SAN JOSE SHELTER FOR THE HOMELESS

COST FREE CLARIFICATION

CLARIFICATION no: 1
Date: 3/29/88

REGARDING Finish height of Dining hall slab

MASONRY LAYOUT
DINING HALL - INTERIOR ELEV.
SCALE 1/2" = 1'-0"
8.20.88. JM

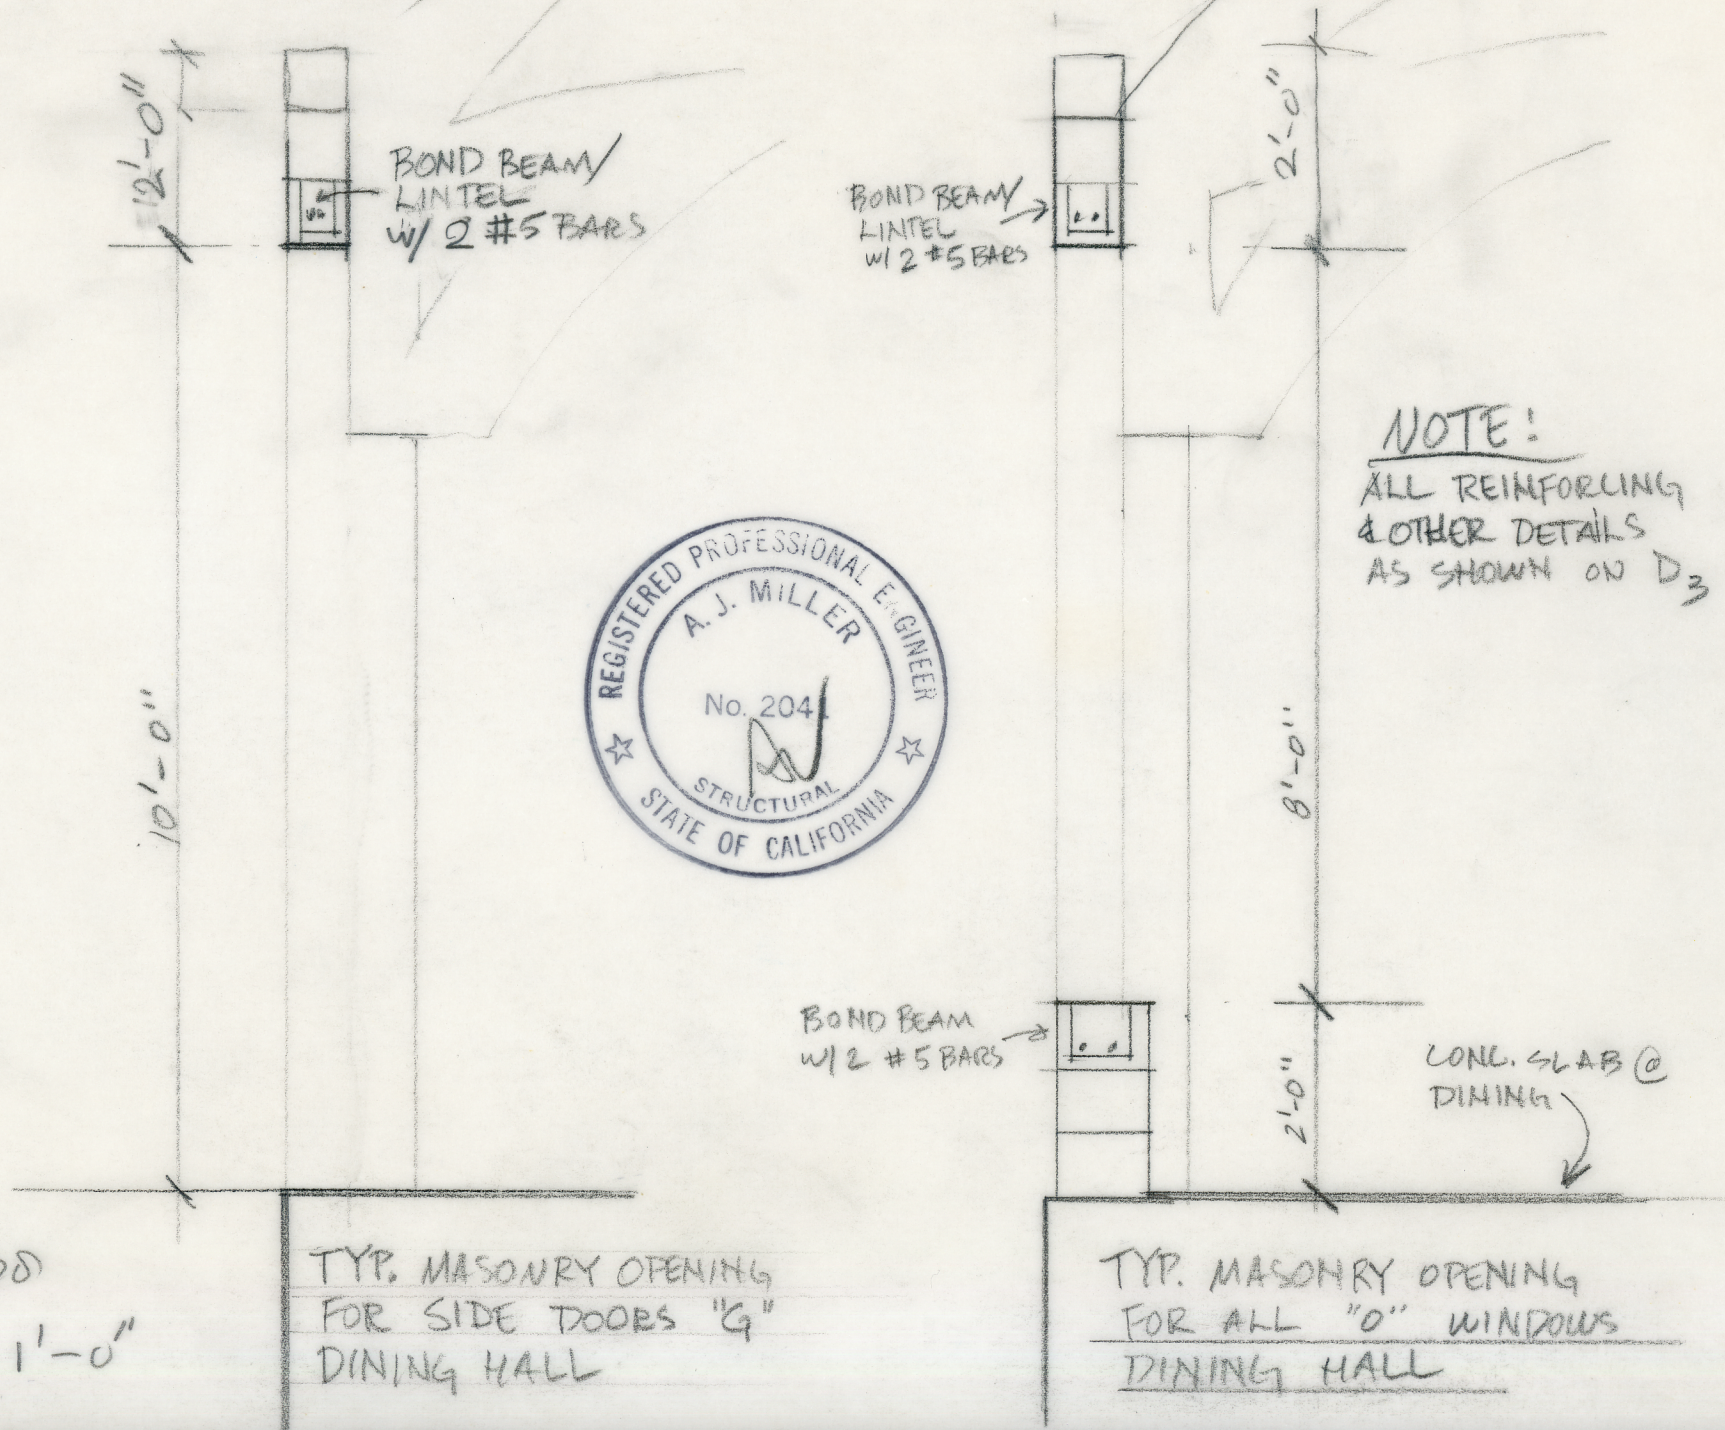
CLARIFICATION # 25

BOND BEAM/LINTEL
AT THIS COURSE

PLASTER
SEE D₃ FOR
DETAILS

DOOR
MASONRY OPENING
6'-4" x 10'-0"

TYP.
WINDOW
MASONRY OPENING
3'-11⁵/₈" x 8'-0"

3 COURSES OF 12" BLOCK

DINING HALL - MASONRY LAYOUT

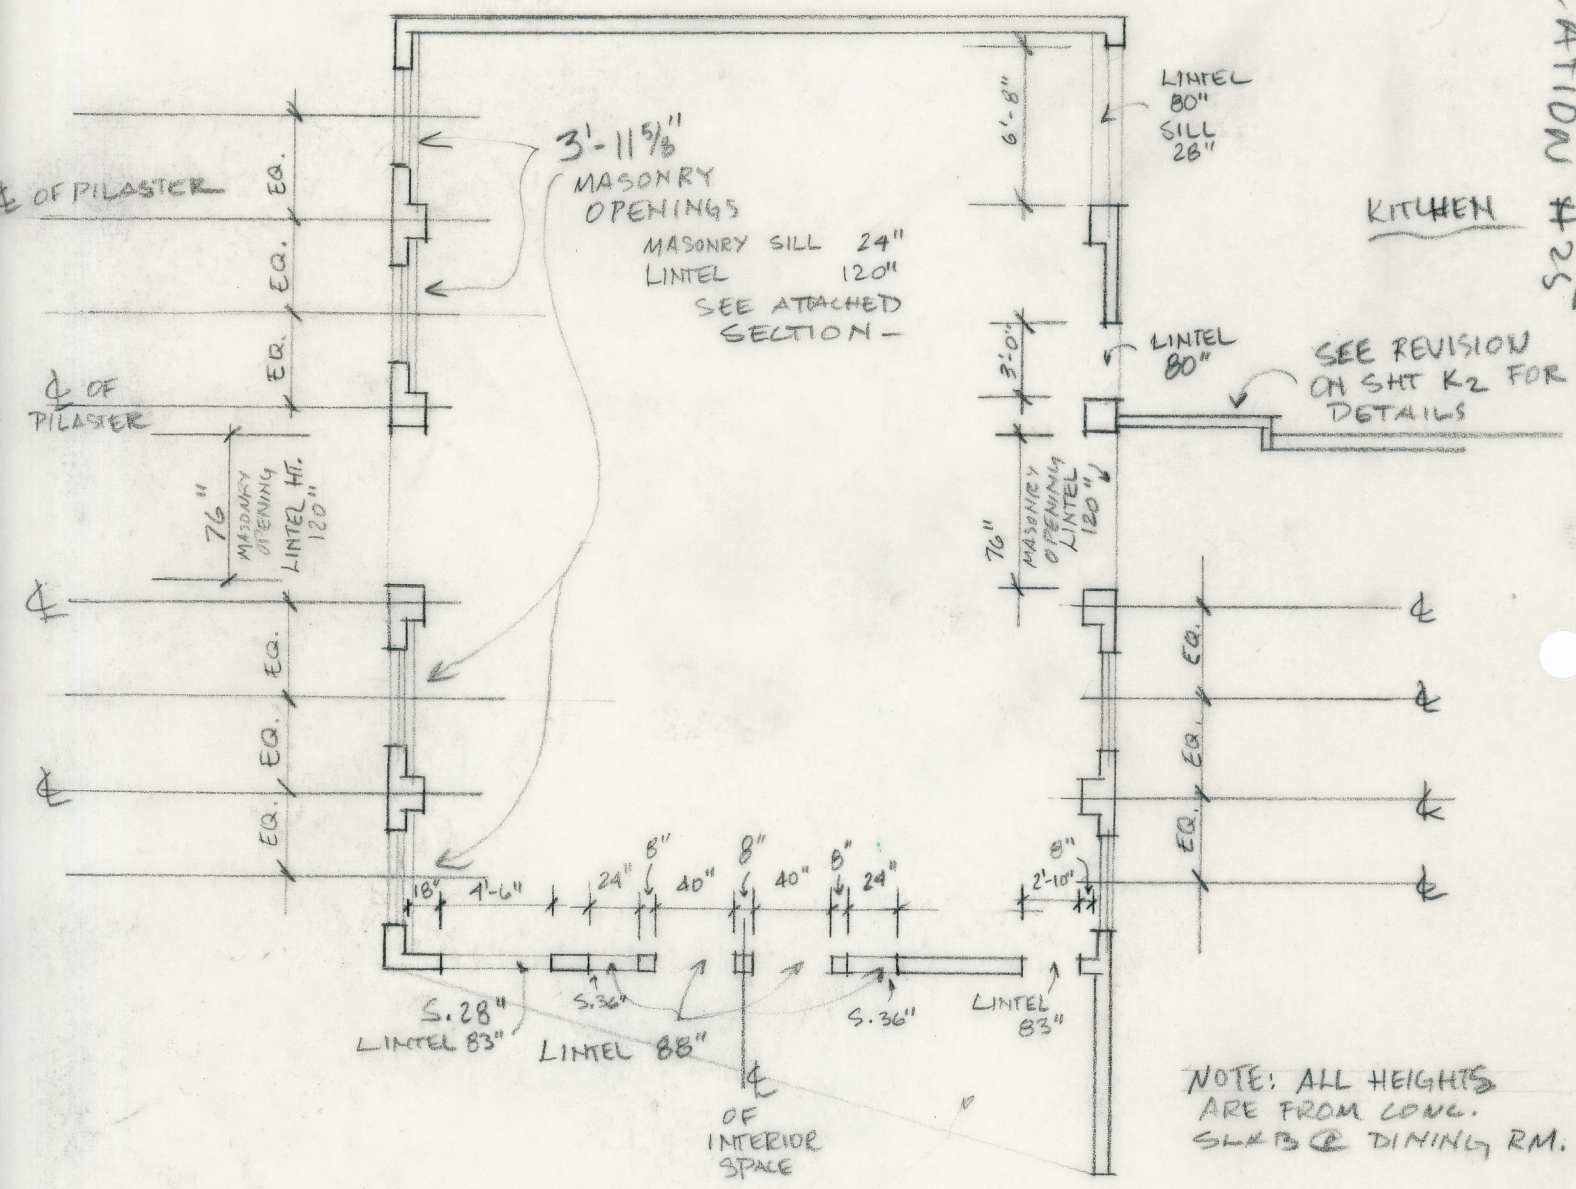
CLARIFICATION #25
